SUNDRY NOTICES AND REPORTS ON WELLS
Do not use this form for proposals to drill or to re-enter an abandoned well. Use Form 3160-3 (APD) for such proposals.

1. Type of Well <input checked="" type="checkbox"/> Oil Well <input type="checkbox"/> Gas Well <input type="checkbox"/> Other		7. If Unit of CA/Agreement, Name and/or No.
2. Name of Operator Stanolind SJ LLC		8. Well Name and No. Ute Indian D-10
3a. Address 310 W. Wall Street, Suite 1000 Midland, TX 79701	3b. Phone No. (include area code) 432-640-0040	9. API Well No. 30-045-10618
4. Location of Well (Footage, Sec., T., R., M., or Survey Description) NENW Section 23, T31N, R15W		10. Field and Pool or Exploratory Area Verde Gallup
		11. Country or Parish, State San Juan, New Mexico

Stanolind SJ plans to plug and abandon the Ute Indian D-10 following the attached procedure. Wellbore sketches showing the current well configuration and the post-job configuration are attached.

**Stanolind SJ, LLC.
Tribal Lease: 14-20-604-1893
Well: Ute Indian D #10
Location: 790' FNL & 2045' FWL
Sec. 23, T. 31 N., R. 15W.
San Juan County, NM**

**Ute Indian D-10
Current**

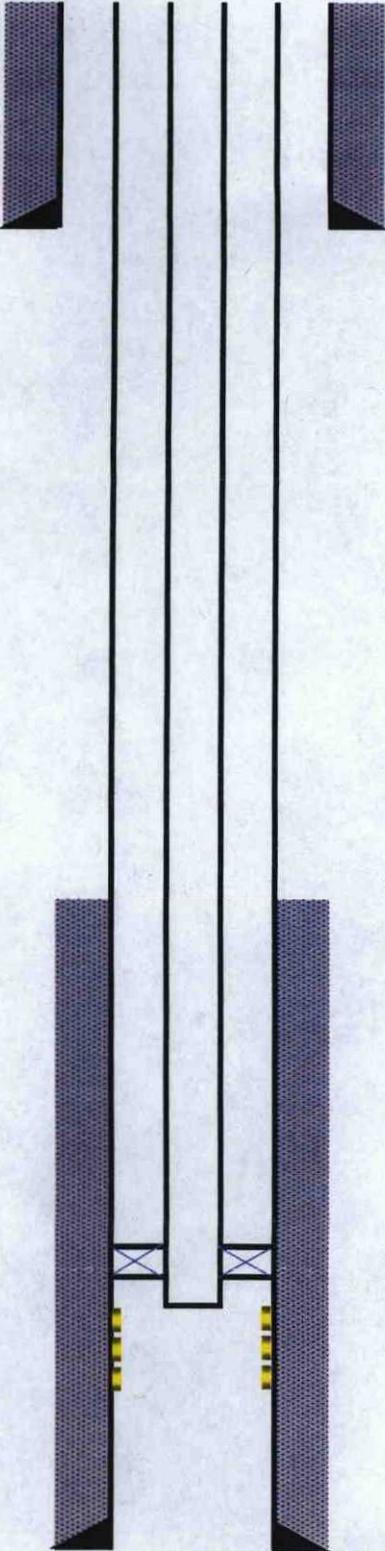
4. A casing leak is expected above the TOC @ 1450'. RIH w/ 2 3/8" tubing and packer. Locate casing leak and report results. Location of the leak will determine the exact procedure, but the following plugs are planned.

**Ute Indian D-10
Proposed P&A**

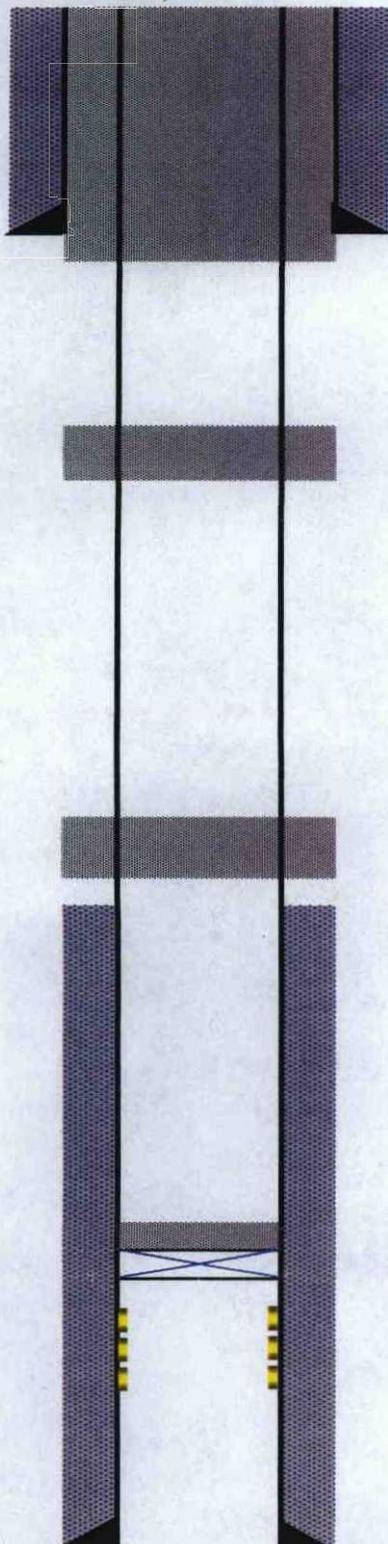
Due to the lack of exact hole size information, all plugs must be increased by a minimum of 25%. For the surface/shoe plug, cement must be circulated to the surface from 120 feet.

After Plug #1 is set, the casing leak must be located and reported to this office so the plugging plan can be modified as necessary.

6d. Plug #2 must be a minimum of 55 sacks of cement.

6e. Plug #3 must be a minimum of 55 sacks of cement.

6f. Plug #4 must be a minimum of 87 sacks of cement.

7. The well must be filled with a wellbore mud sufficient to stabilize the wellbore. In the absence of any formation pressure data provided by the operator, this mud will have a minimum weight of **9 ppg**. The mud must be left between all plugs.
